Objection Letter Appendix

226 Finchley Road NW3 (Ref 2019/1991/P)

10 June 2019

Current rear layout at 226 Finchley Road

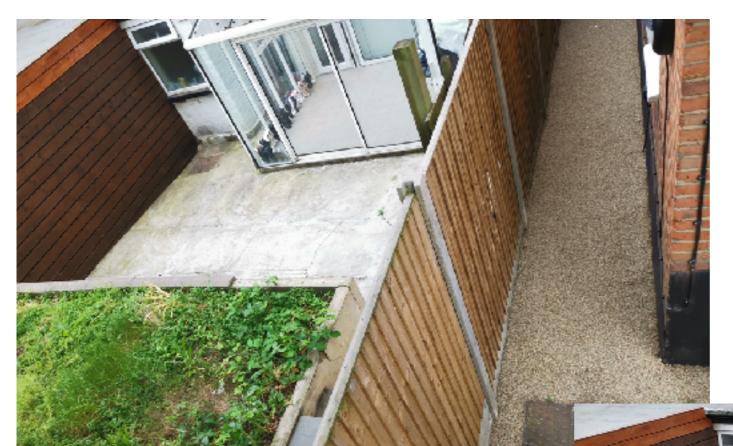
Impact on garden amenity space in Conservation Area to be assessed

Proximity to 228 Langland Mansions

Encroaching pipes

Encroaching window opening

Less than
1m width
alleyway
belonging to
Langland
Mansions

Proximity and Loss of Privacy

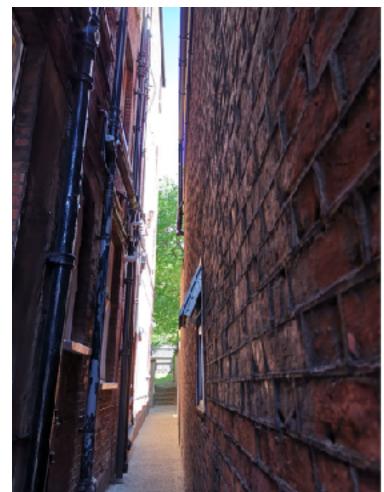
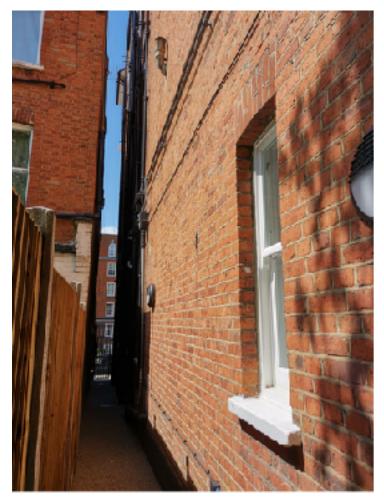
Existing small window overlook into two windows of our bedroom and has already caused significant loss of privacy

Loss of DIRECT sunlight impact

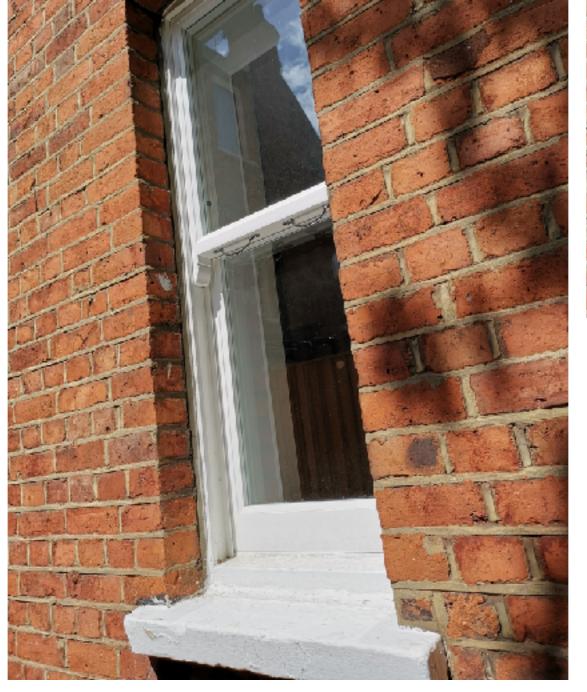
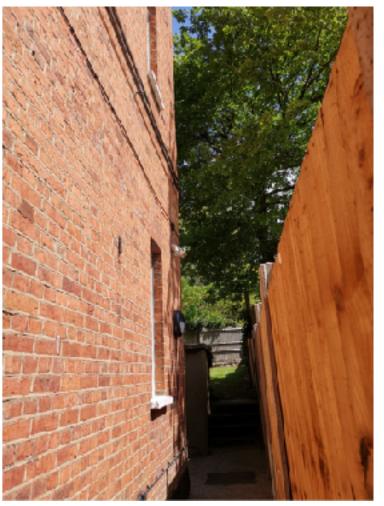
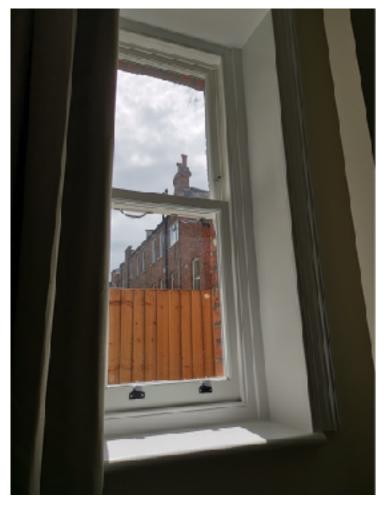
Direct sunshine enjoyed by the single window into our master bedroom (taken from outside)

Loss of DIRECT sunlight impact

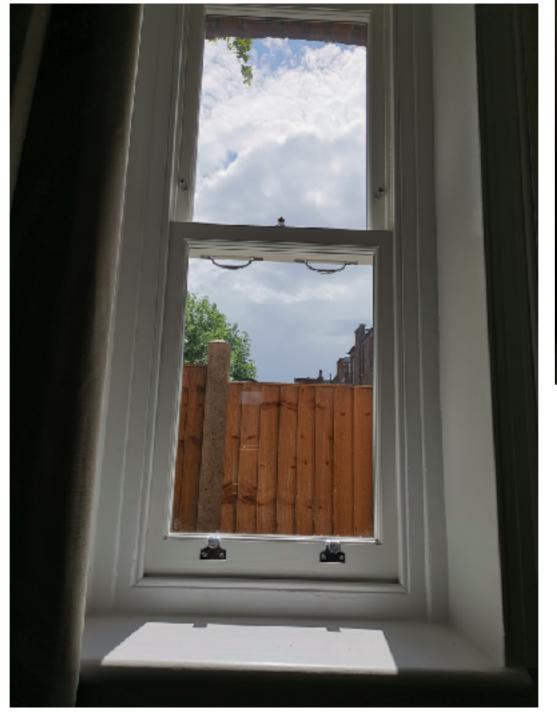
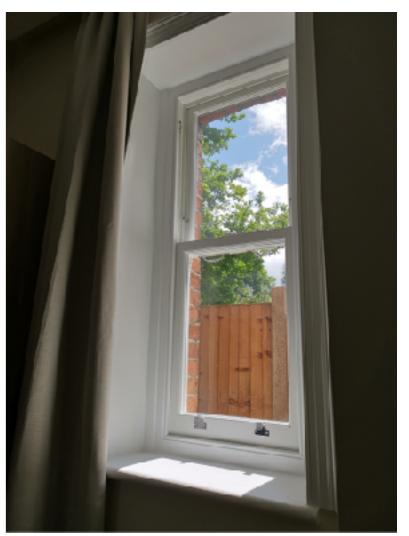
Direct sunshine enjoyed by the single window into our master bedroom (taken from inside)

Loss of DIRECT sunlight impact

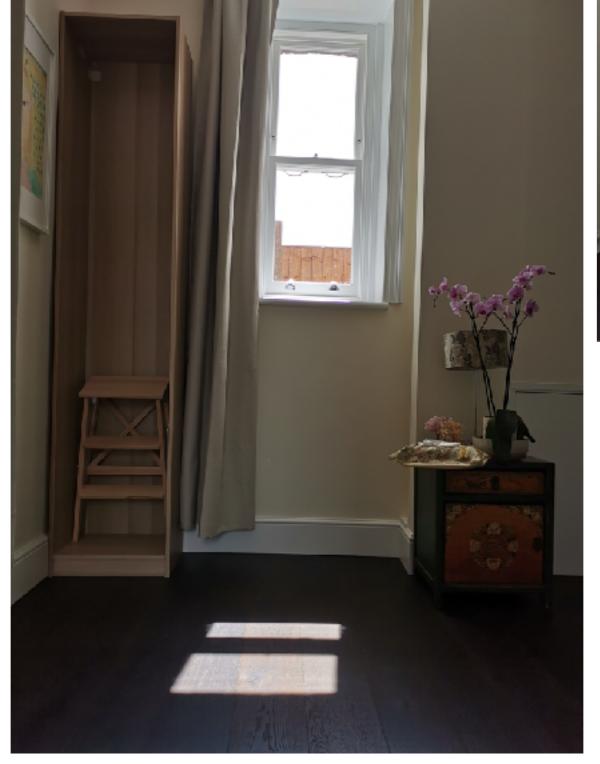
Direct sunshine enjoyed by the single window into our master bedroom (taken from inside)

Terminal clearances

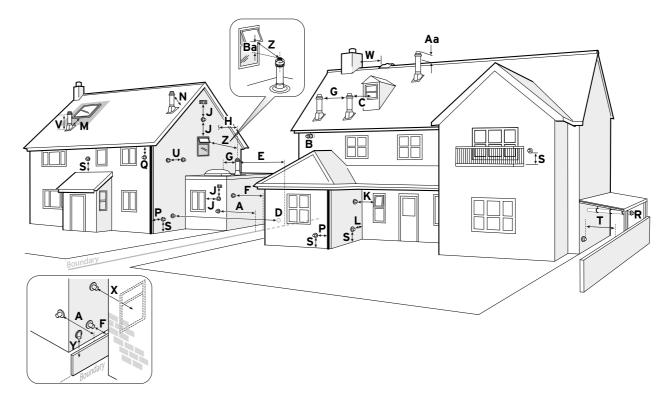
Vaillant Installation
Manual (page 30) "X" requires boiler
flue terminal clearance
of 2m if there is an
opening in adjacent
building. If there is no
opening in adjacent
building, then
minimum 60cm
clearance only is
needed (see "F")
